CITY AND COUNTY OF SAN FRANCISCO PUBLIC UTILITIES COMMISSION

INSTALLATION OF 16-INCH AND 36-INCH, AND RELOCATION O 8-INCH DUCTILE IRON WATER MAINS AT VARIOUS LOCATIONS ON 19TH AVENUE FROM HOLLOWAY AVENUE TO LINCOLN WAY

TYPICAL STEEL PIPE DETAILS

WD-2775-7 E-31375

TYPICAL FIELD BUTT JOINT DETAIL

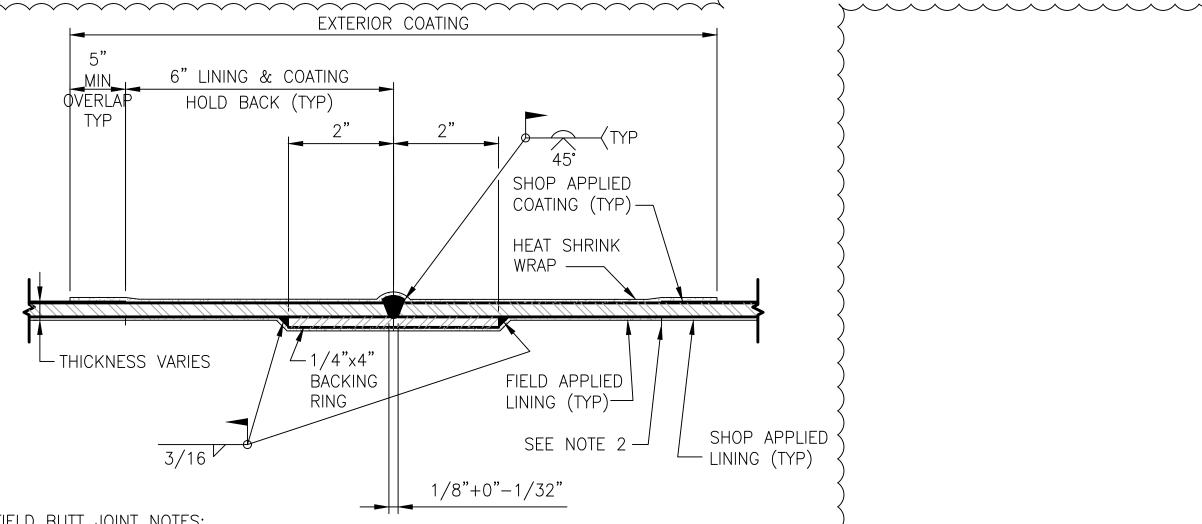
\ 03/10/21 PCO #3 - REVISE SECTION DETAILS CCSF 2013 NO. DATE DESCRIPTION BY APPR'D 04/22/2021 NAVD88 REVISIONS
